## Addendum No. 2

City of Coquitlam

RFP No. 25-104

### Austin Works Yard Roof Replacement

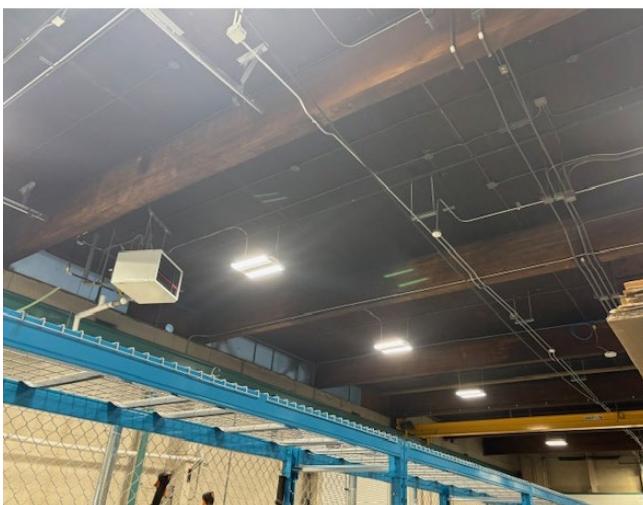
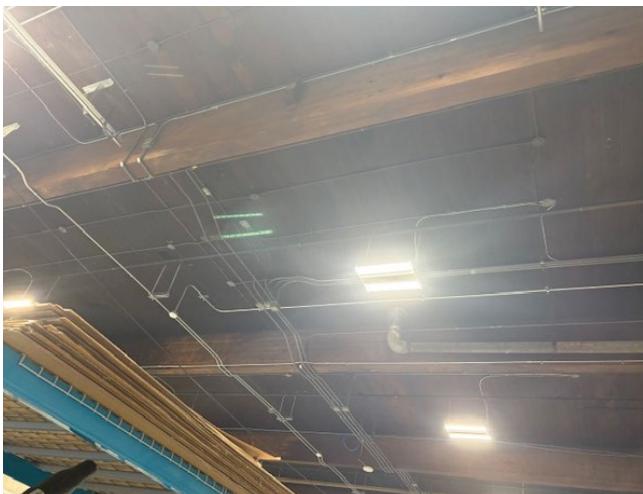
- Q1. The RFP states that a 5 year company warranty is required, however the specifications state a different warranty, can the City confirm which warranties they are looking for?  
**A1. The City is seeking a 5-year contractor warranty as well as a 10-year manufacturer warranty.**
- Q2. Does Bldg. RA200 require the 8' x 8' drain sumps, as the specs state to adjust the ISO thickness to accommodate sumps as needed? However, this roof does not have a base ISO specified.  
**A2. Yes, this roof area requires 8' X 8' drain sumps. Adjust insulation sum thickness to accommodate tapered insulation thickness.**
- Q3. I would like to request photos of Building 1 showing the underside of the roof. We did not have the opportunity to review the condition of the underside during the site meeting, and these photos would be helpful for our assessment.  
**A3. See images below.**
